BOROUGH OF
SPRING LAKE HEIGHTS, N.J.

ZONING PERMIT

Project
New Residence For:
Nicholas and Emily Bilotti
585 Monmouth Avenue,
Spring Lake Heights, NJ
Block 76 Lot 7

Zoning Data and Site Plan

Robert Dooley RA

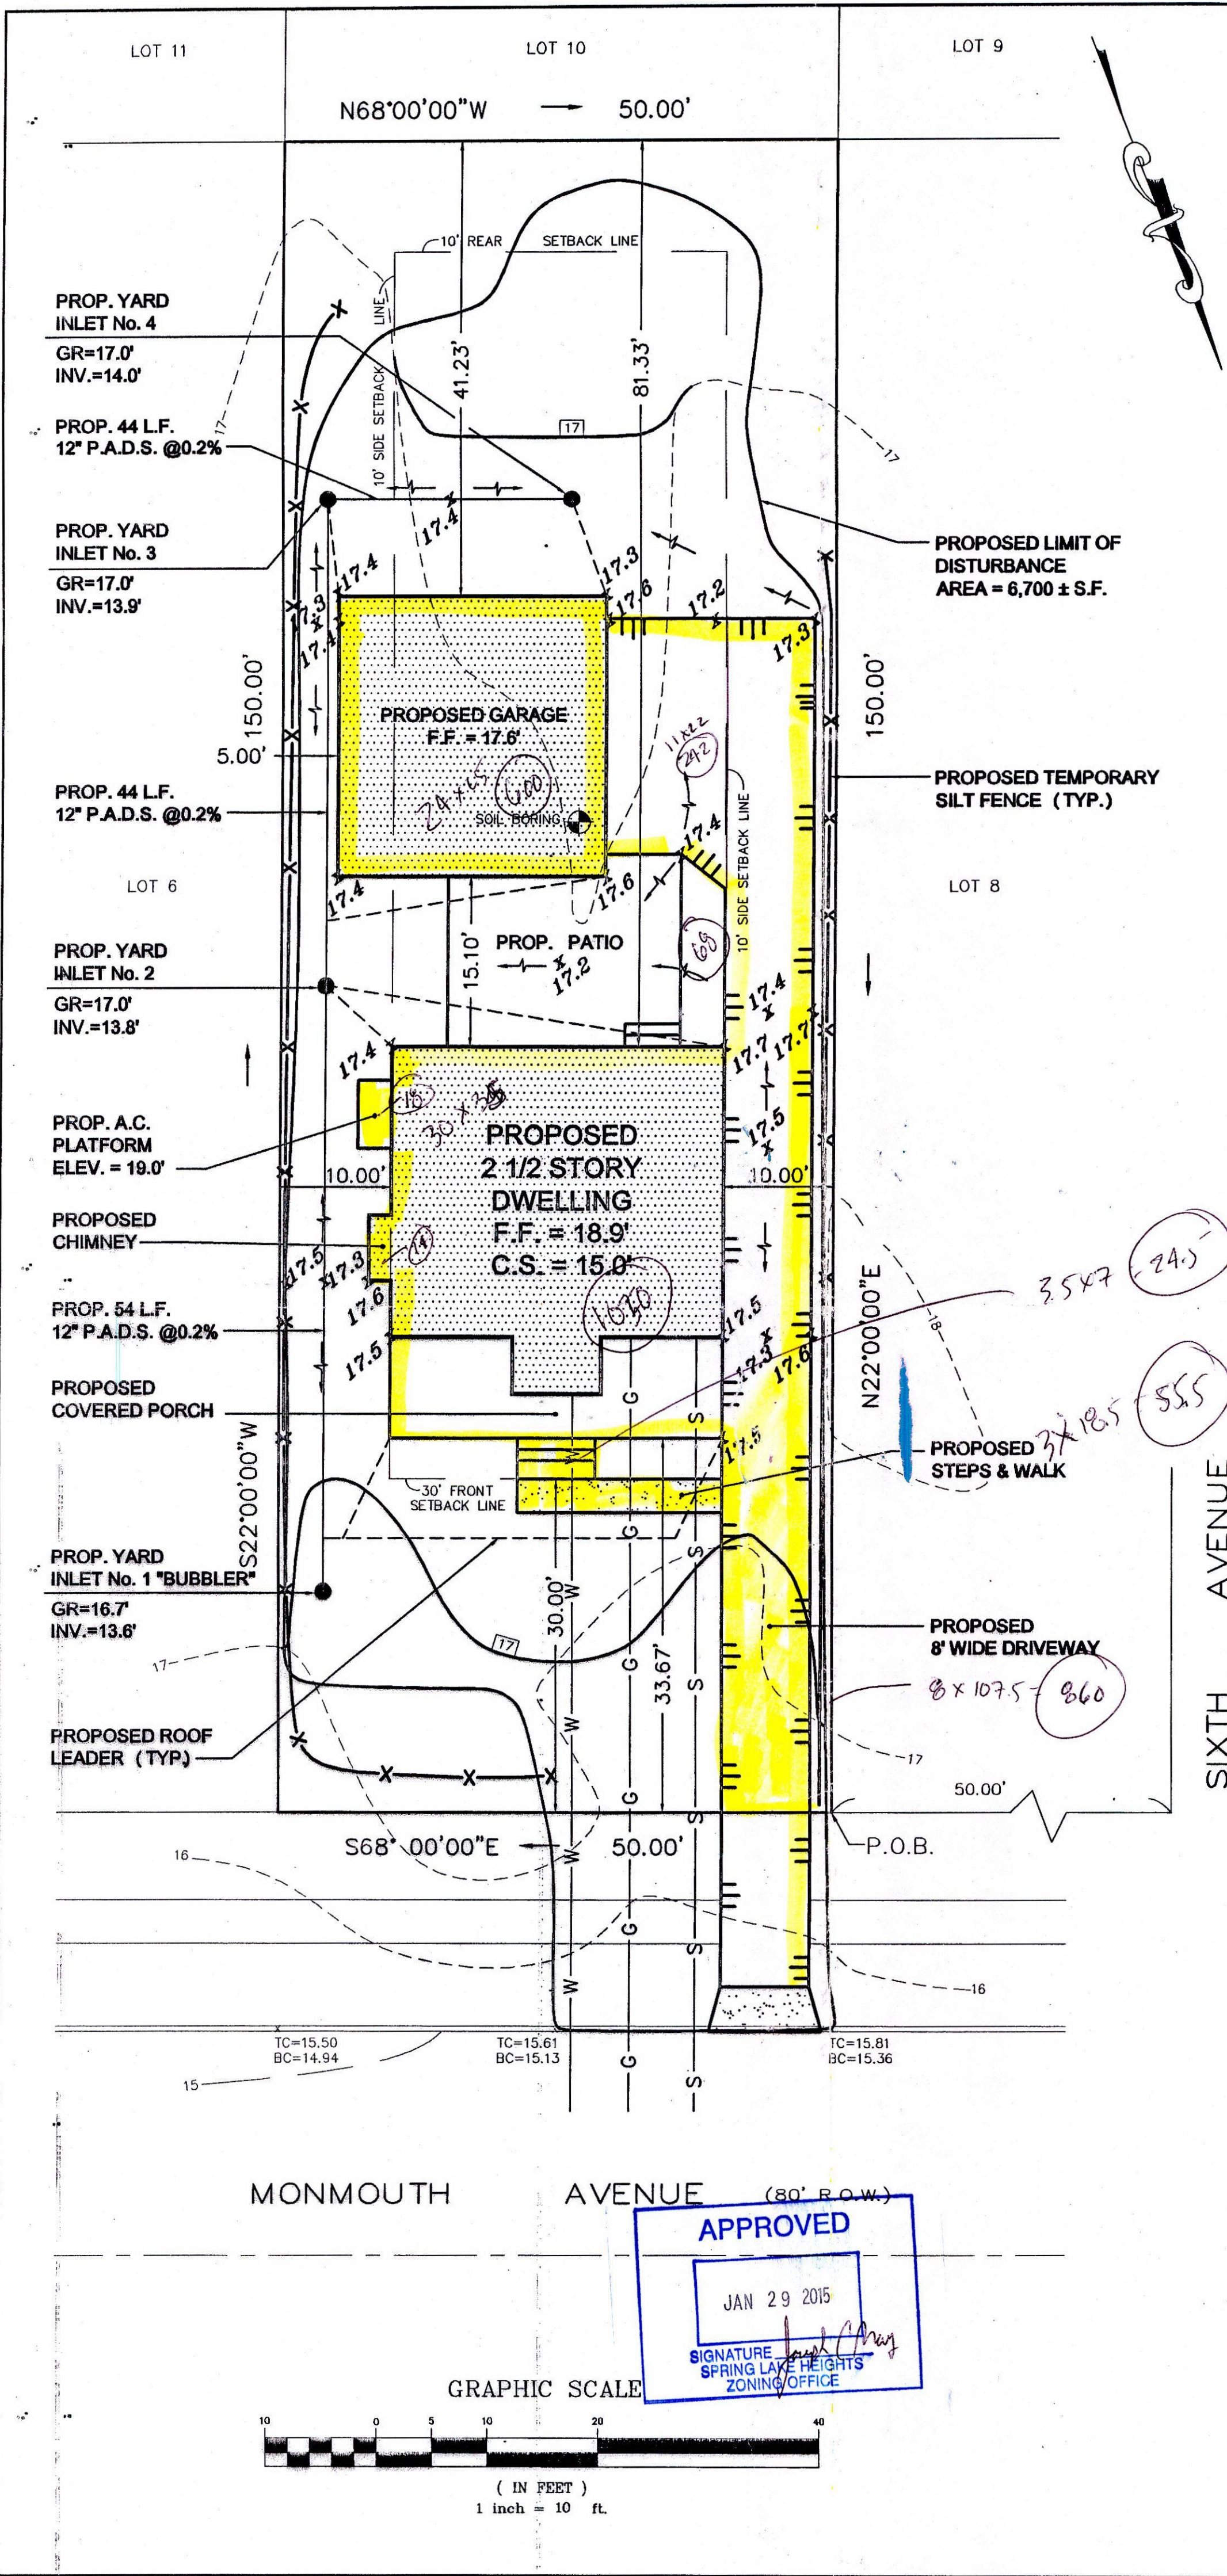
Brielle 4@verizon.net
NEED
info
not
ACCEPTABLE
12/29/14

- All construction to be in accordance with the Borough of Spring Lake Heights construction code requirements.
- Survey error of closure more accurate than 1: 15,000.
- Proposed Recharge pipe is provided to allow 1 cf of storage per 12 sf of proposed structure. Proposed structures are 1646 sf requiring 137.2 cf of required. Provided is 120 lf of recharge pipe providing 2.07 cf of storage per linear foot, total 248 cf provided.
- Vertical Datum 1988 NAVD.
